**FINAL DRAINAGE REPORT
FOR
ESTATES AT CATHEDRAL PINES,
EL PASO COUNTY, COLORADO**

October 2023

JR ENGINEERING
5475 Tech Center Drive
Colorado Springs, CO 80919
(719) 593-2593

Culvert Performance Curve Plot: N. Pond Culvert

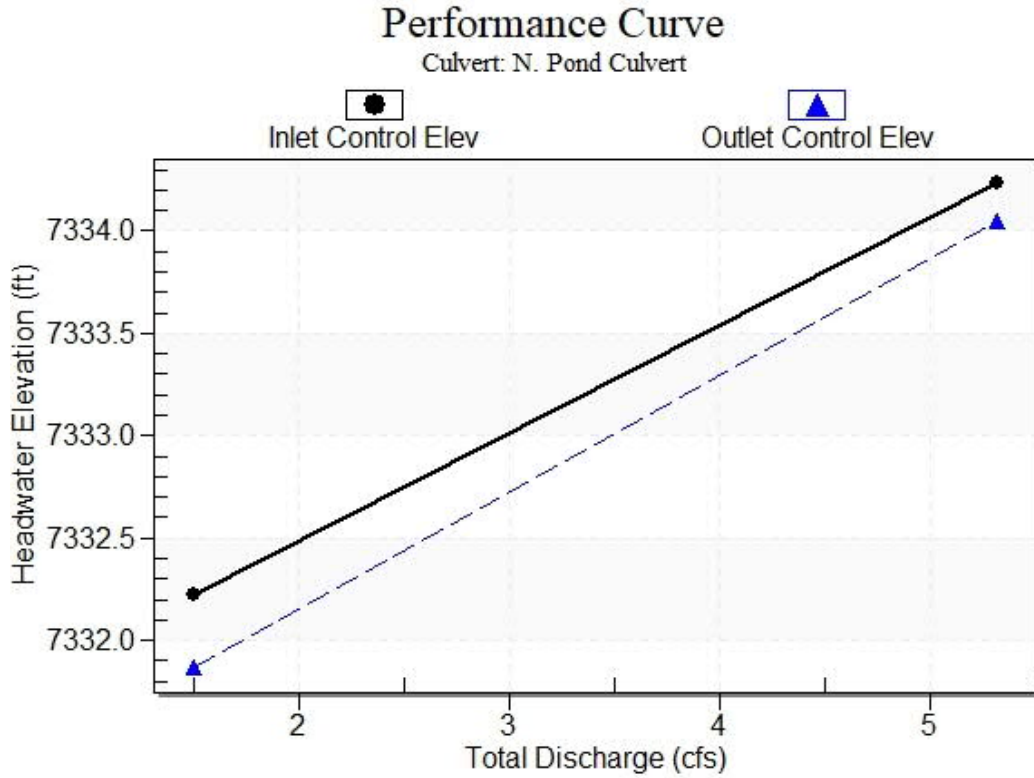
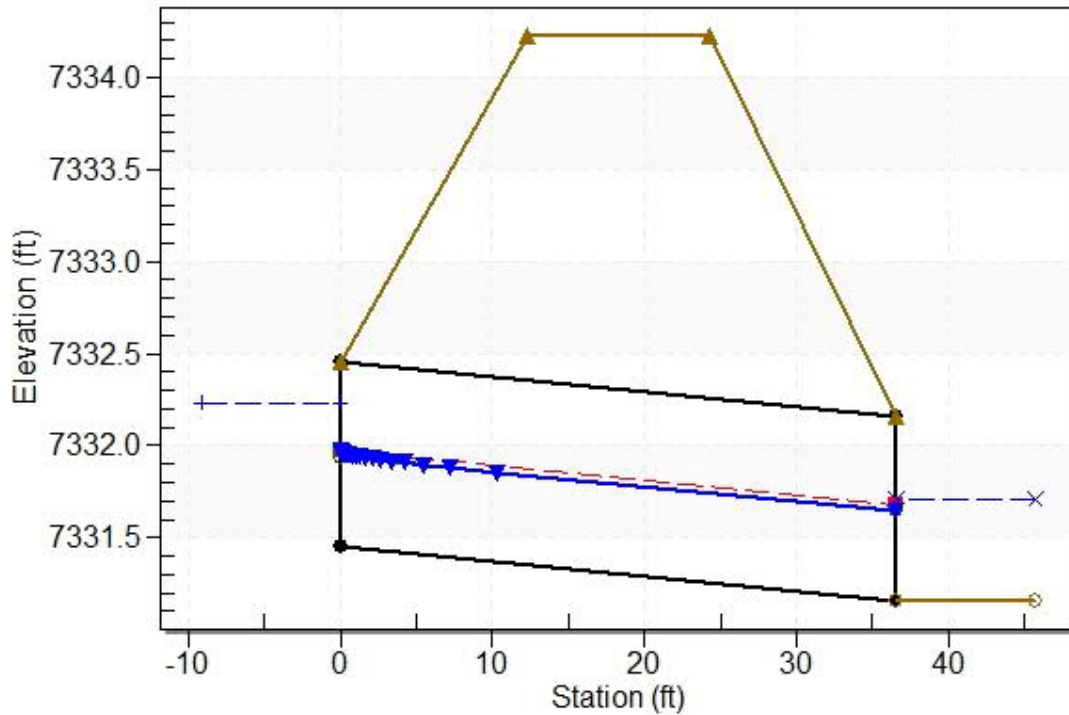
Design Point (DP5)? Use DP notation to ensure it is clear which culverts apply and they can easily be compared to the CDs

Culvert Performance Curve Plot: N. Pond Culvert

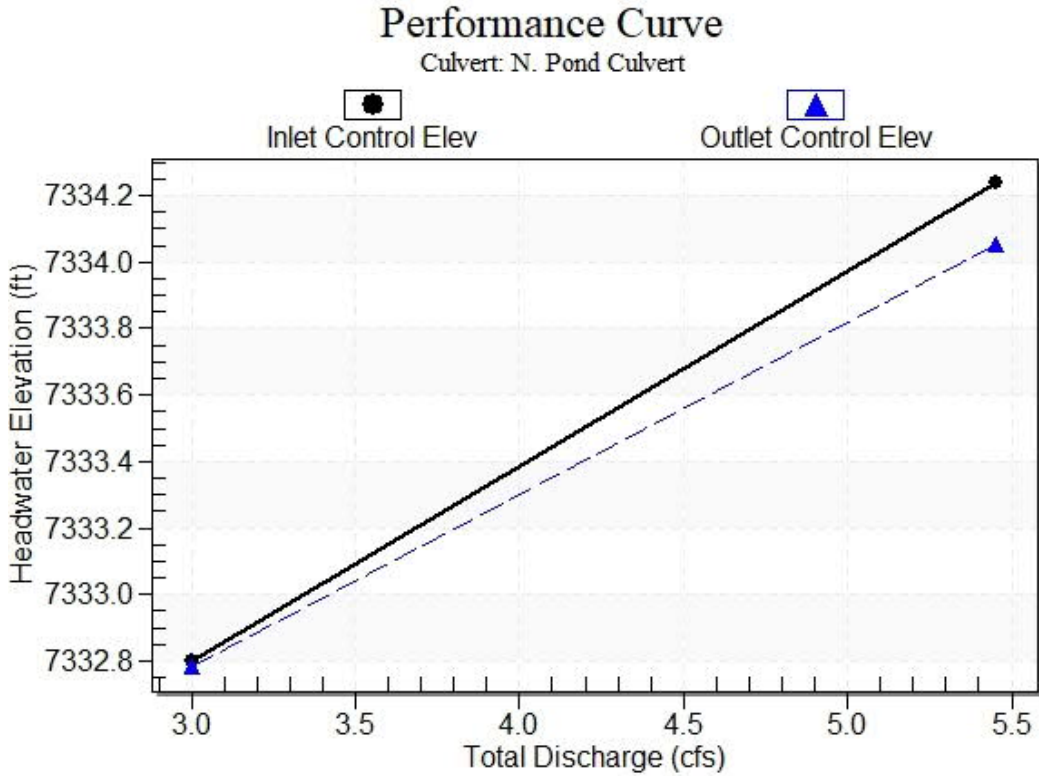
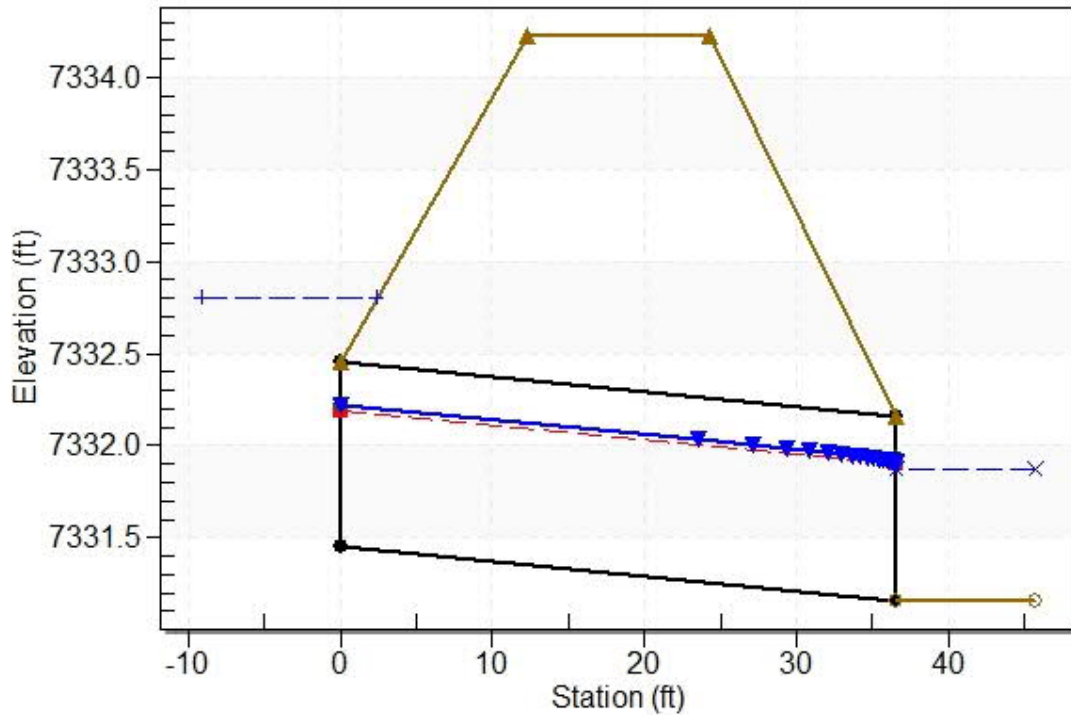
Design Point (DP5)? Use DP notation to ensure it is clear which culverts apply and they can easily be compared to the CDs

Culvert Performance Curve Plot: Basin J Culvert

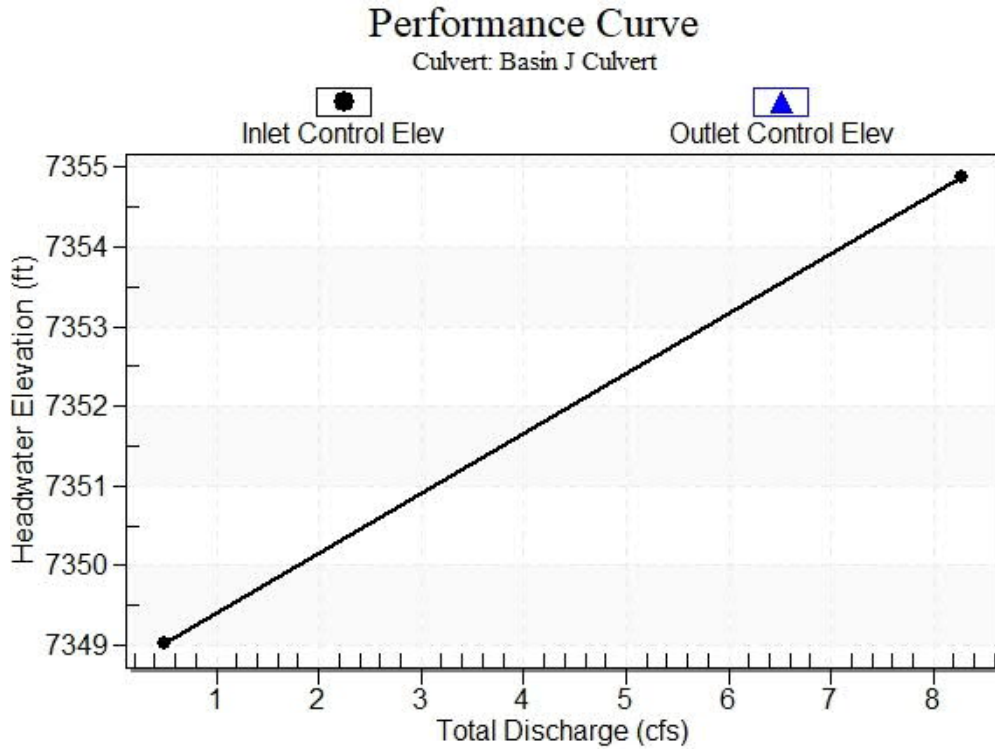
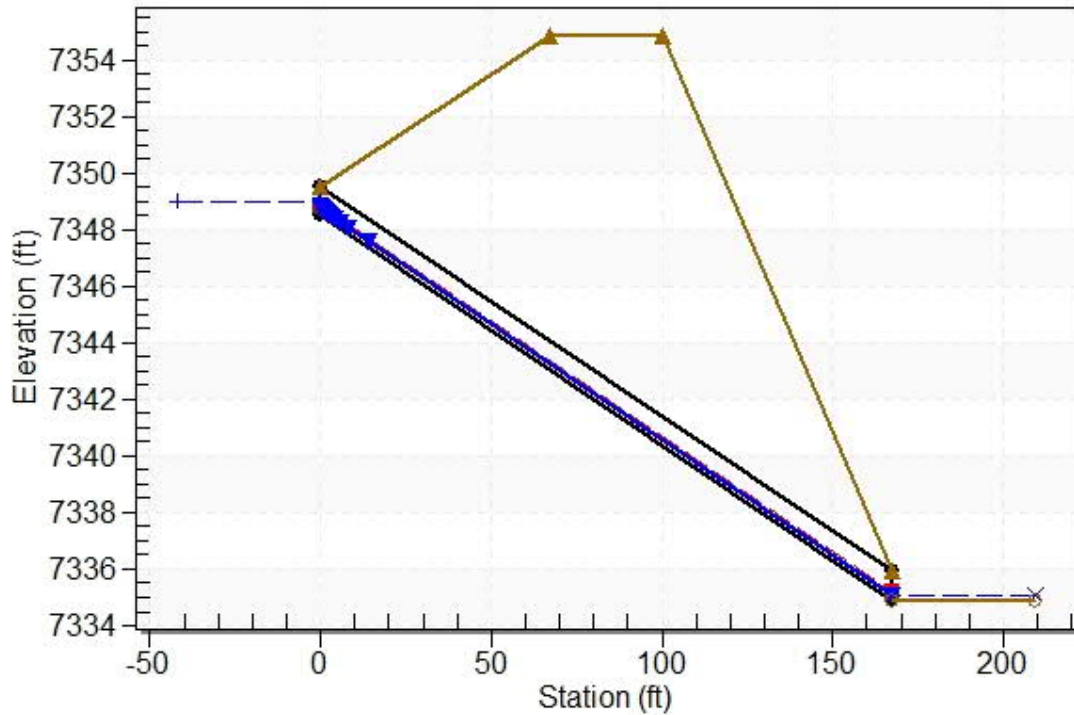
Design Point (DP4)? Use DP notation to ensure it is clear which culverts apply and they can easily be compared to the CDs

Culvert Performance Curve Plot: Basin J Culvert

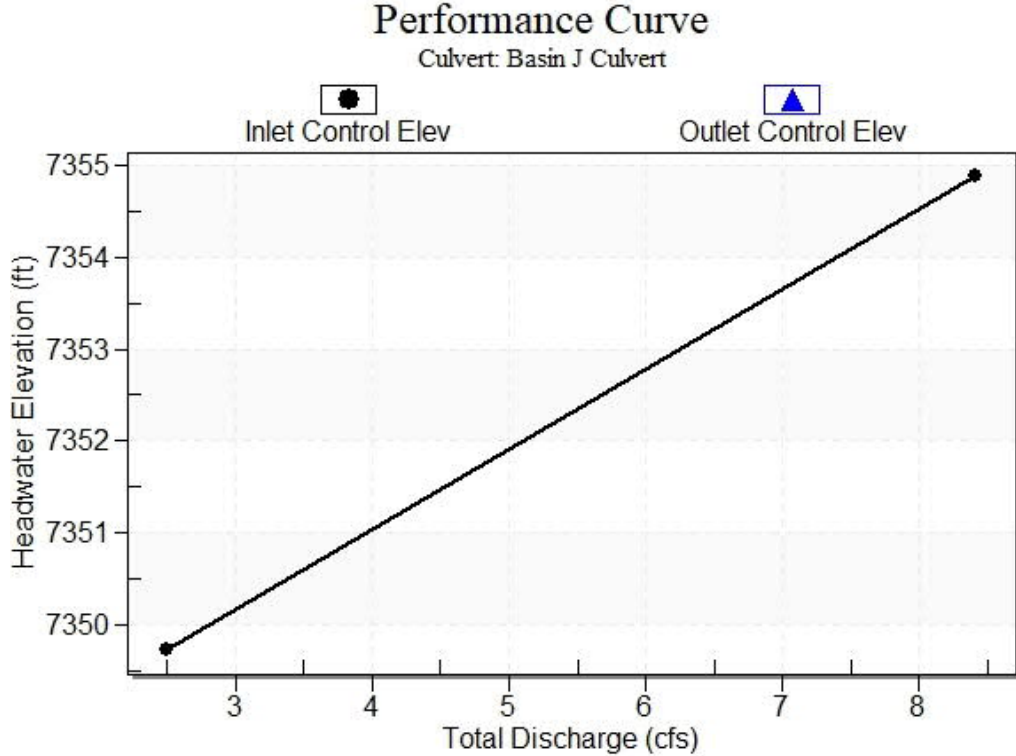
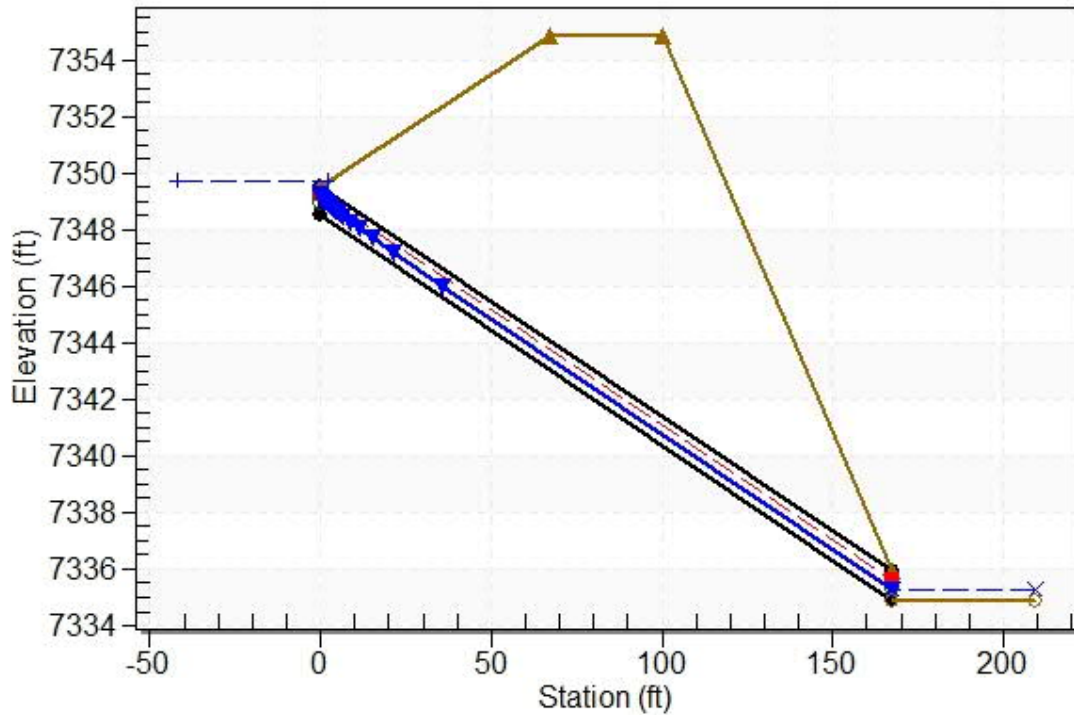
Design Point (DP4)? Use DP notation to ensure it is clear which culverts apply and they can easily be compared to the CDs

STORMCAD MAP
ESTATES AT CATHEDRAL PINES
JOB NO. 25260.00
09/08/23
SHEET 1 OF 1

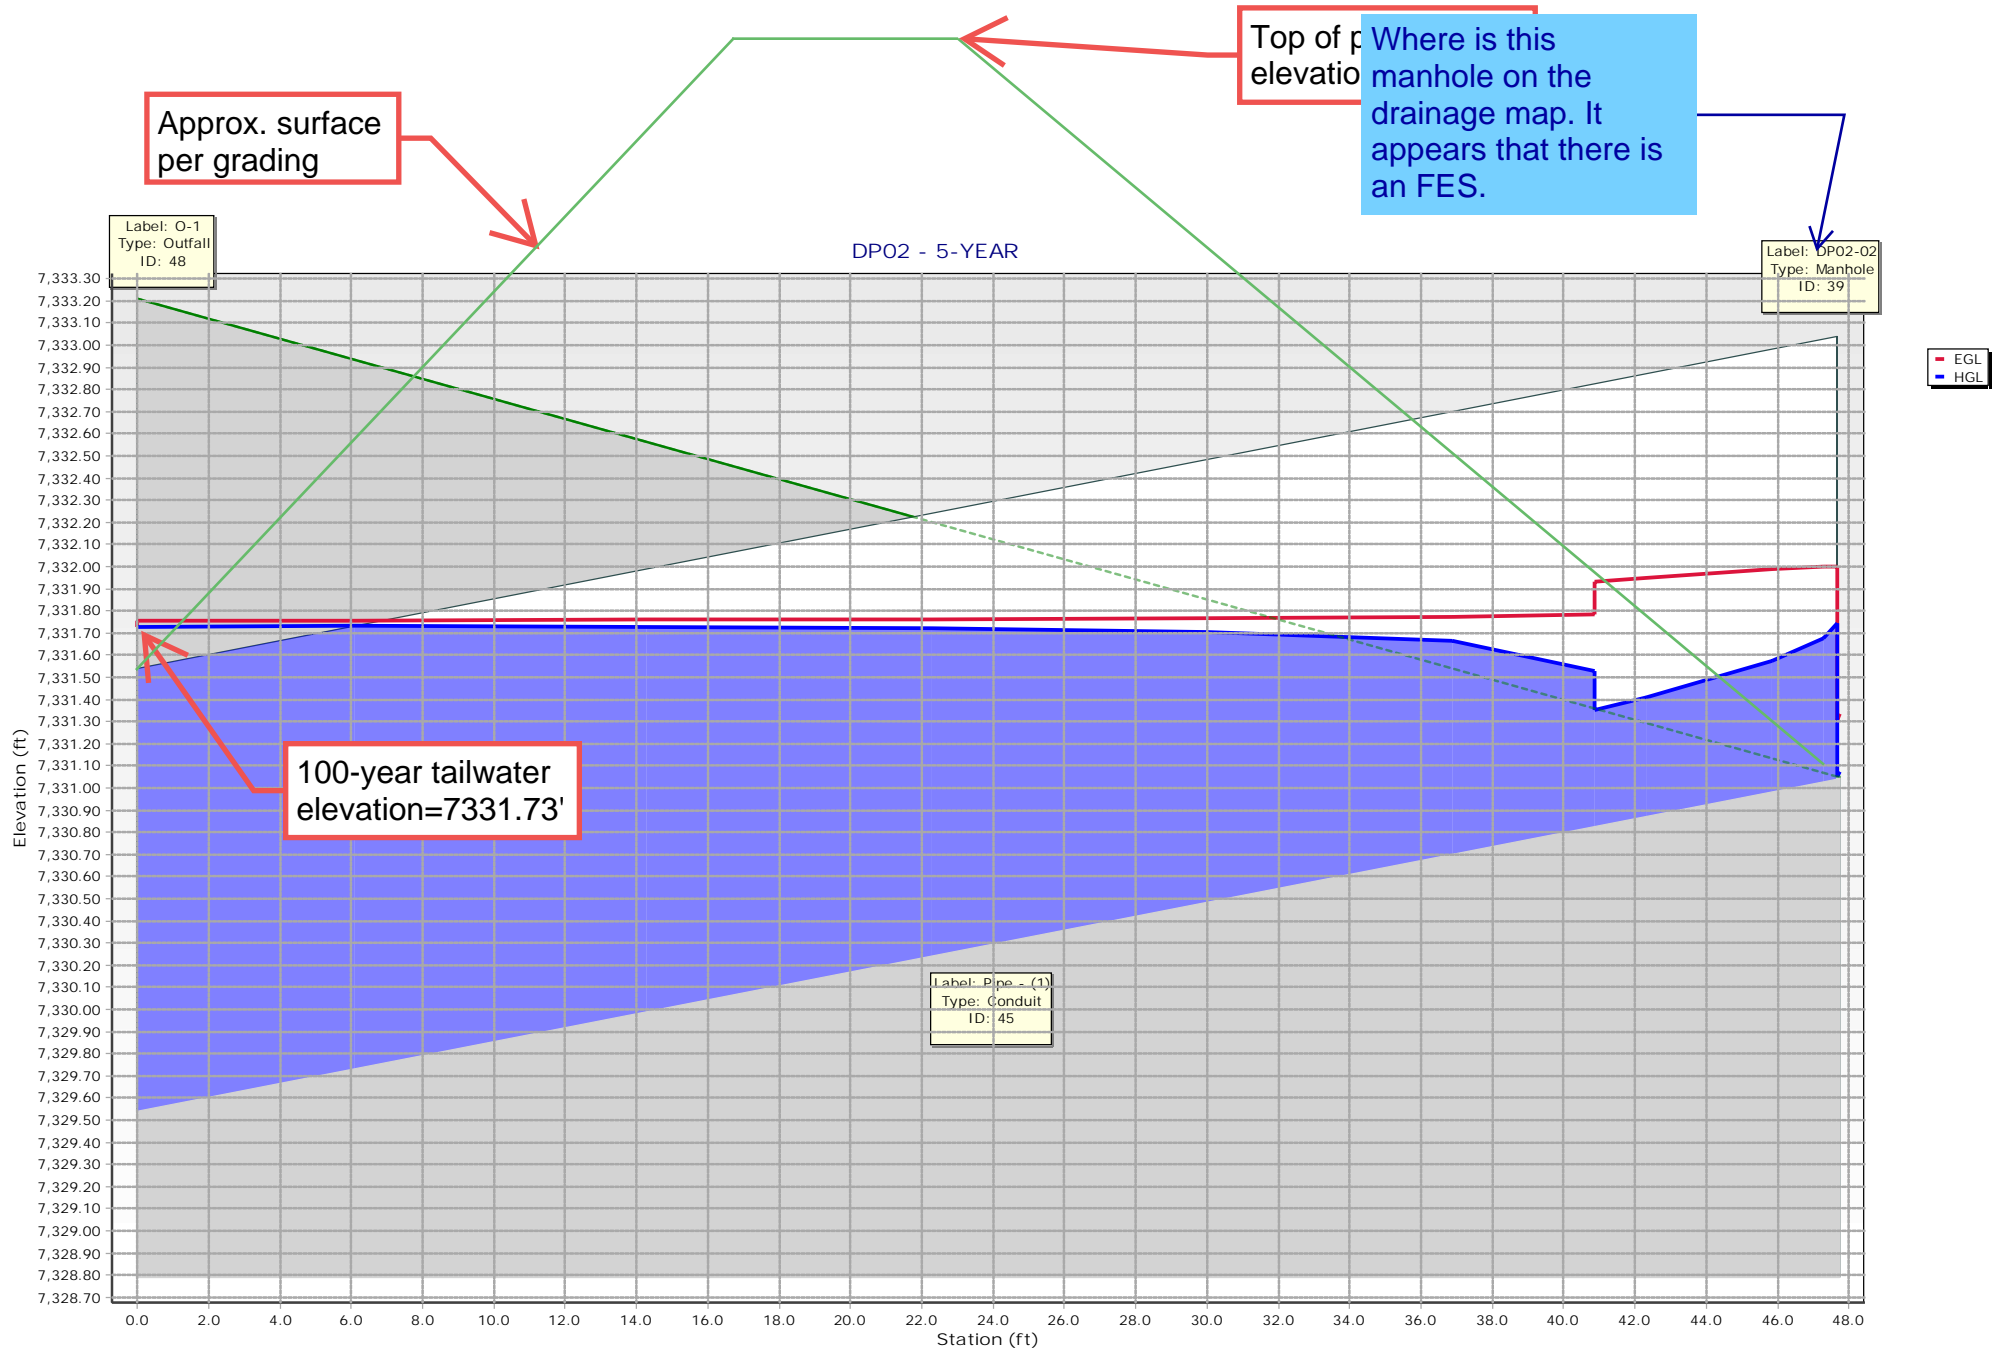
For DP3 and 5 - tailwater does not appear to be modeled based on the HGLs shown on the profiles. Verify. Tailwater for those outfalls should be normal depth in the downstream ditches.
